Subject: McGuire Nuclear Station Unit 2
Docket No. 50-370
Relief Request 01-009

RELIEF REQUEST 01-009

McGuire Nuclear Station - Unit 2

SECOND 10-YEAR INTERVAL REQUEST FOR RELIEF NO. 01-009

ITEM # COZ.021.007
I.D.# ZSLC-WZ59
BY: [Signature]
DATE: 9/23/00
Pg. 6 of 9

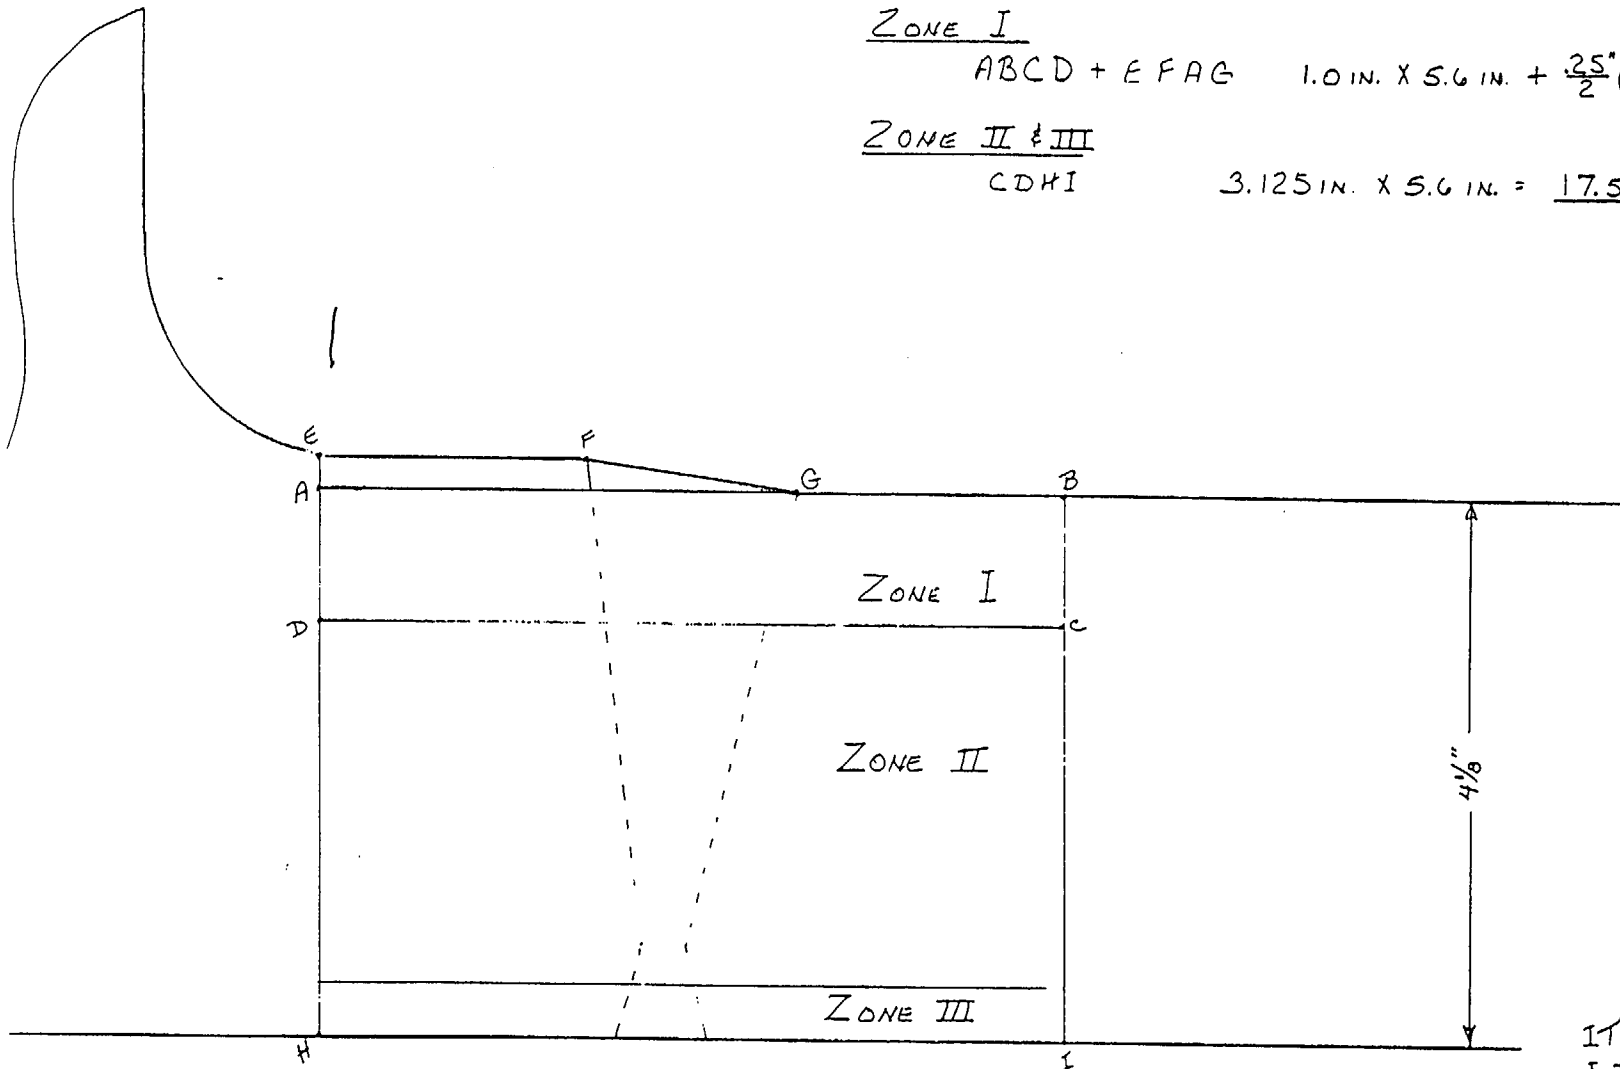
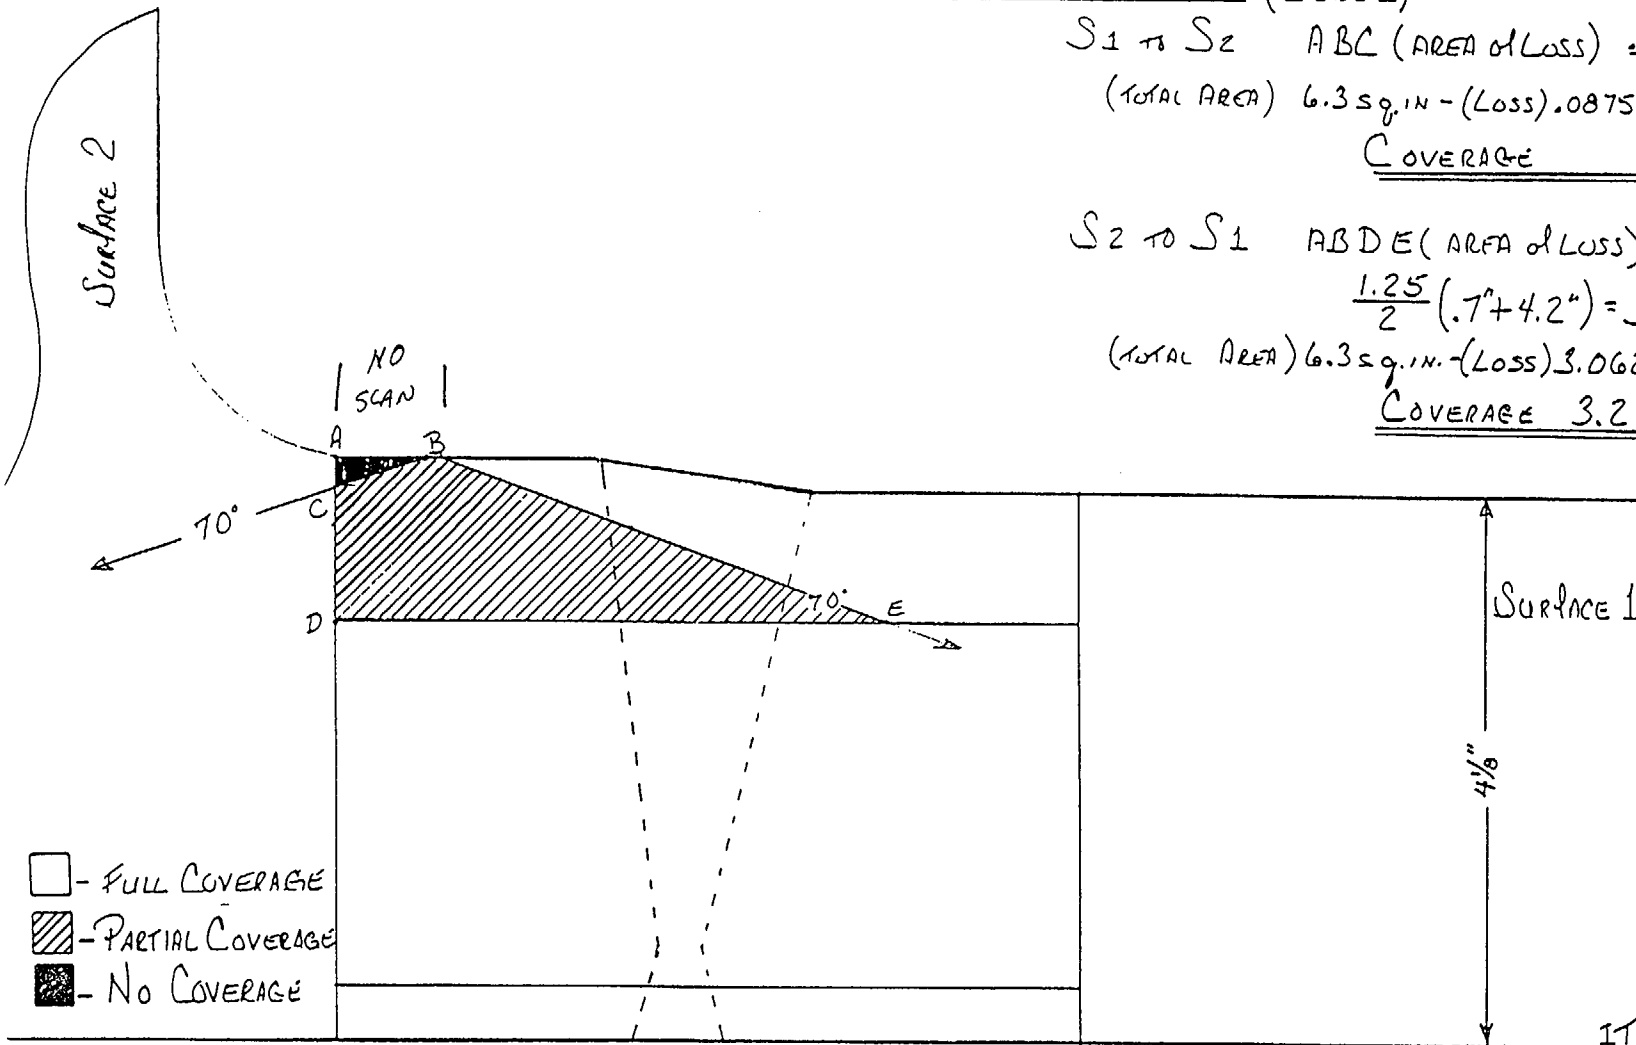
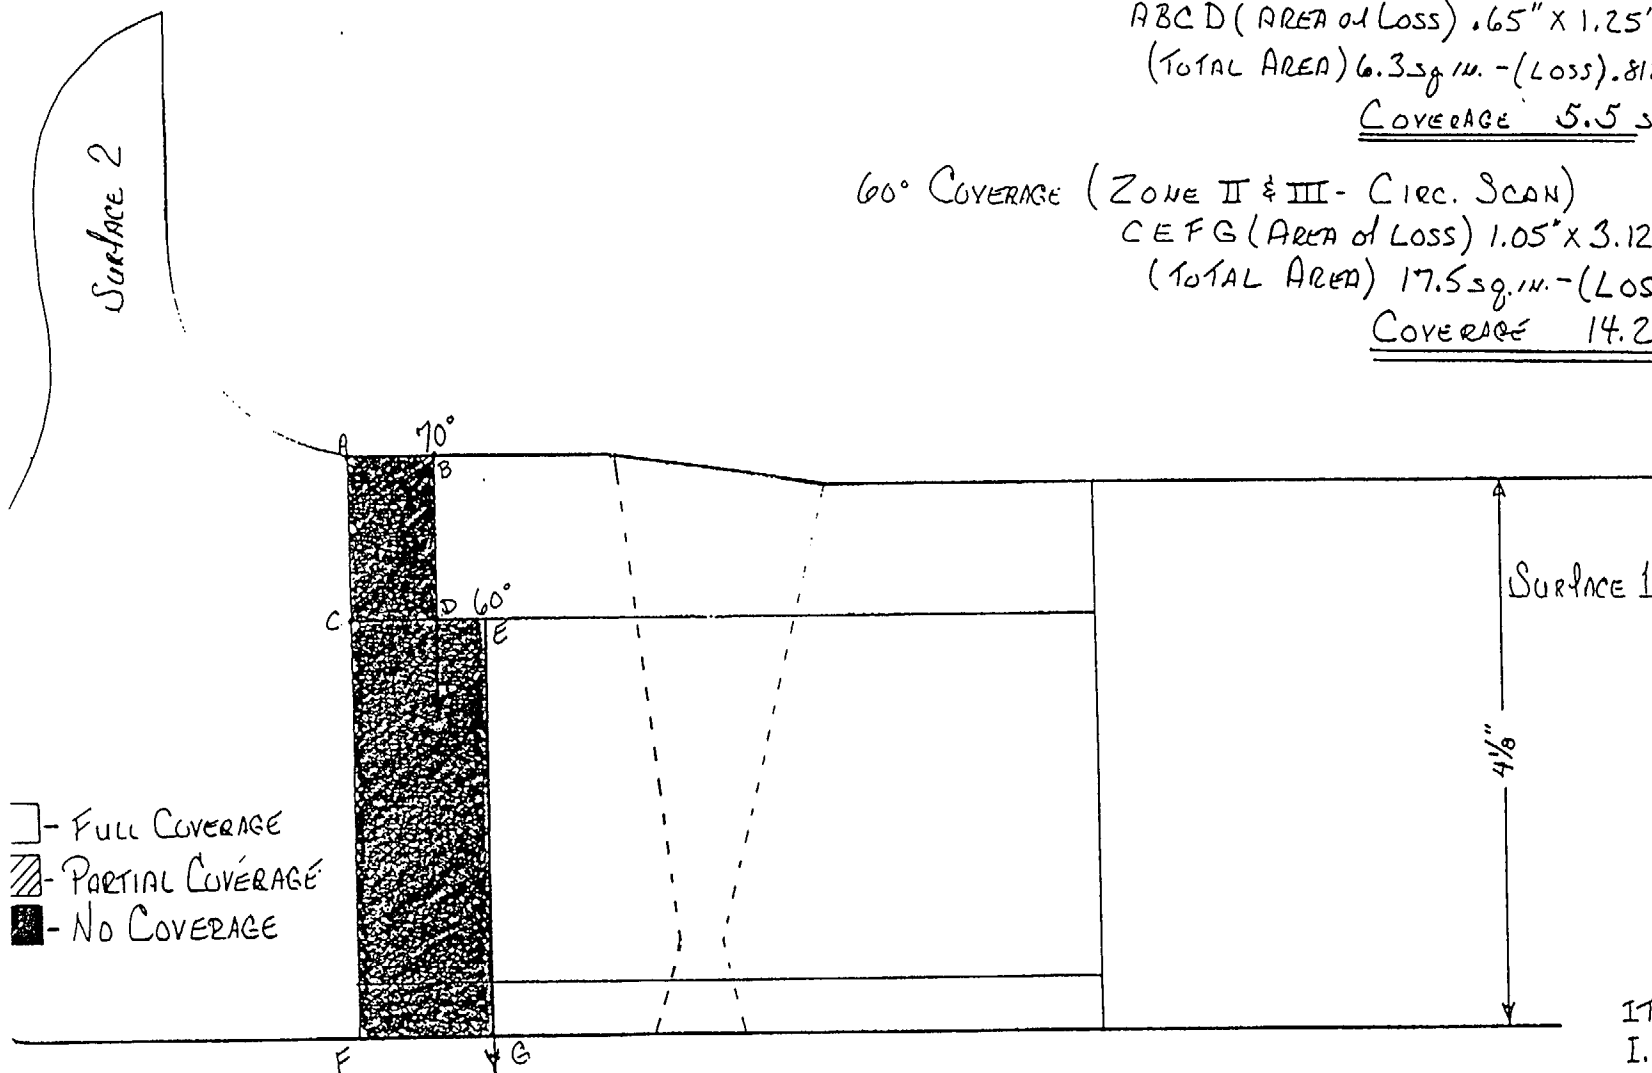
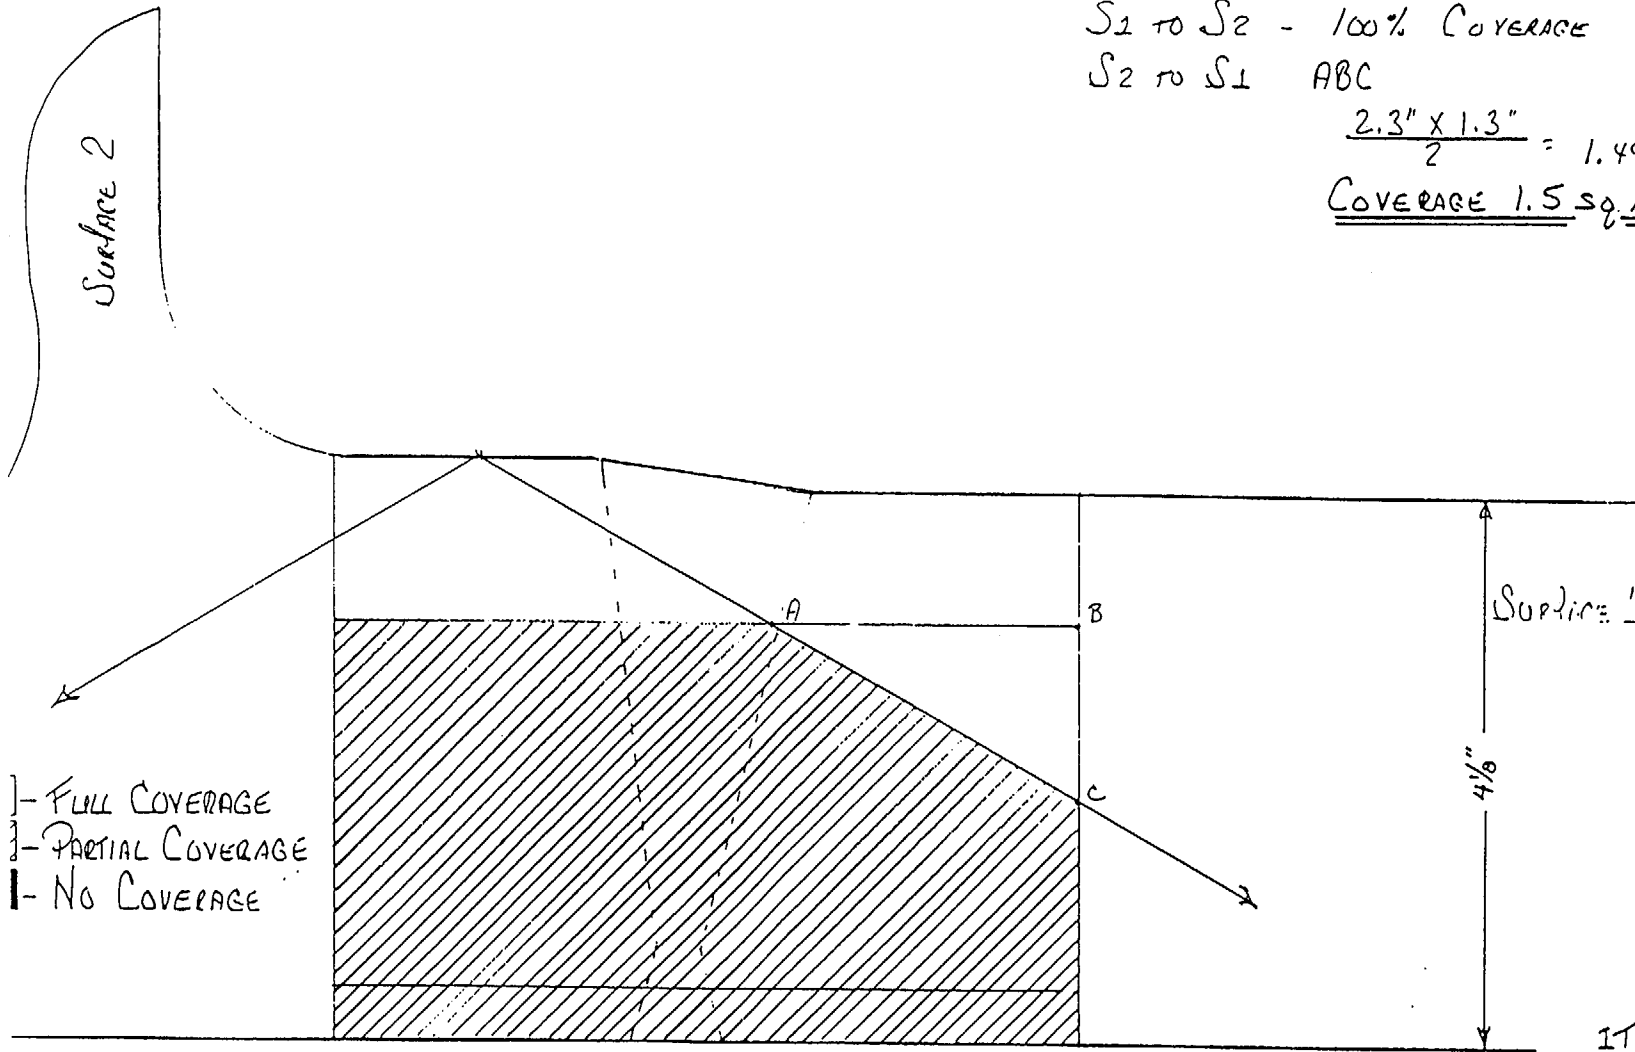
During the ultrasonic examination of this weld,
greater than 90% of the required examination volume as
allowed by Code Case N-460 could not be obtained. As
shown in Attachment 2, the examination coverage was
limited to 74.40% of the required examination volume.
This is a ferritic nozzle to shell weld where access
is limited to the vessel shell side only. The
percentage of coverage reported represents the
aggregate coverage obtained from one scan
perpendicular to the weld axis and two scans, 180°
apart parallel to the weld. The weld design prevented
any axial scan from the nozzle side. In order to

achieve more coverage the weld would have to be re-designed to allow scanning from both sides.

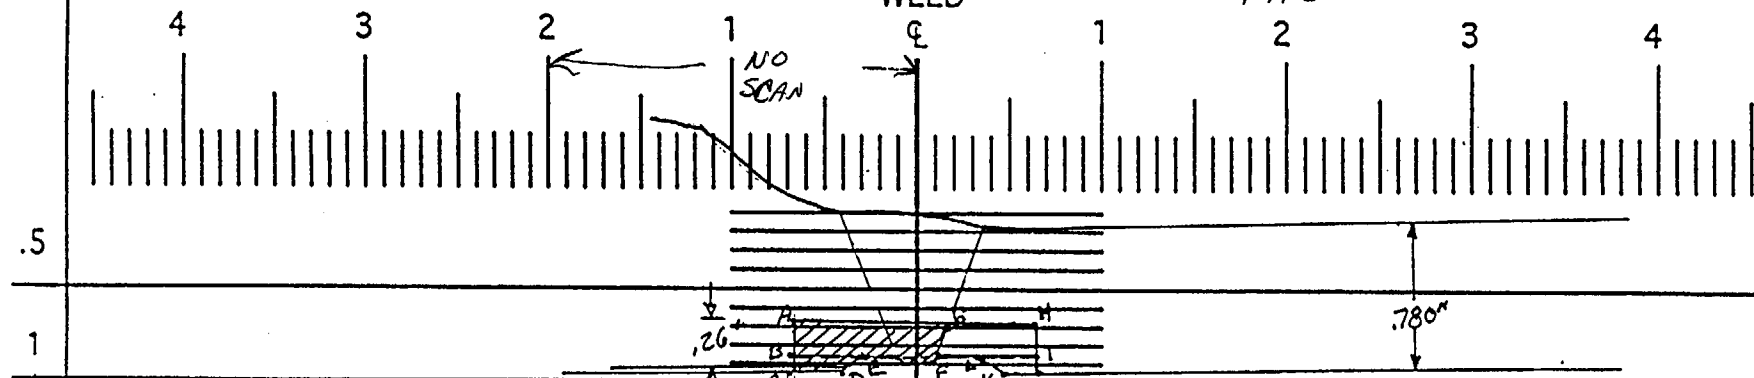
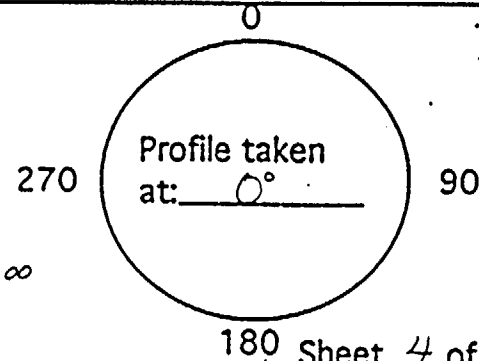
During the ultrasonic examination of this weld, greater than 90% of the required examination volume as allowed by Code Case N-460 could not be obtained. As shown in Attachment 3, Pages 1-4 the examination coverage was limited to 59.86% of the required examination volume. This is a stainless steel pipe-to-valve weld where access is limited to the pipe side only. The percentage of coverage reported represents the aggregate coverage obtained from one scan perpendicular to the weld axis and two scans, 180° apart parallel to the weld. The weld design prevented any axial scan from the valve side. In order to achieve more coverage the weld would have to be re-designed to allow scanning from both sides.

Station WNS Unit 2 Rev 2 File No. 2 RCPA-TE Sheet 5 of 6
 Subject COS.021.081 By JAMES H. BESOR Date 9-4-00

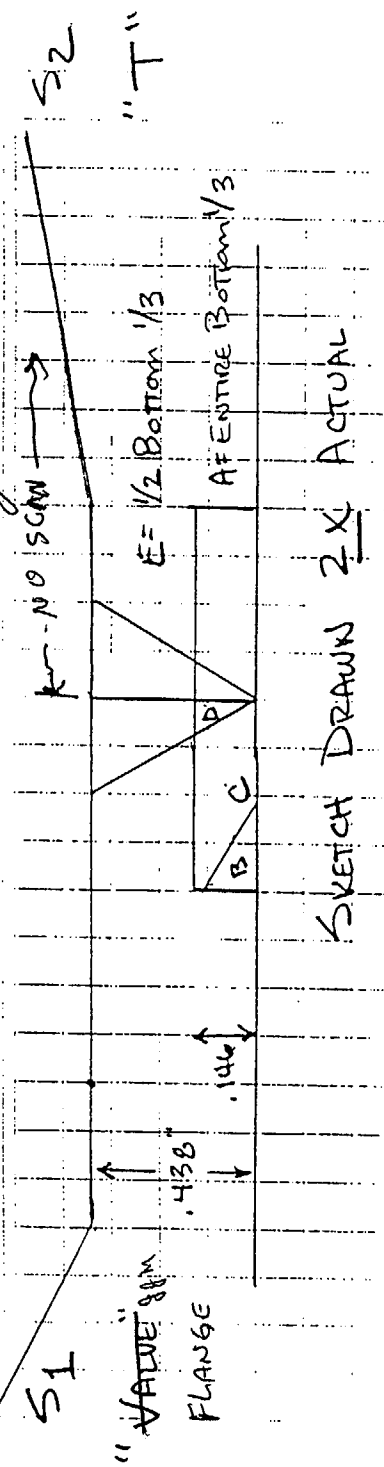
During the ultrasonic examination of this weld, greater than 90% of the required examination volume could not be obtained. As shown in Attachment 3 (Pages 5-10), the examination coverage was limited to 58.17% of the required examination volume. This is a stainless steel flange-to-tee weld where access is limited to the flange side only. The percentage of coverage reported represents the aggregate coverage obtained from one scan perpendicular to the weld axis and two scans, 180° apart parallel to the weld. The weld design prevented any axial scan from the tee side. In order to achieve more coverage the weld would have to be re-designed to allow scanning from both sides.
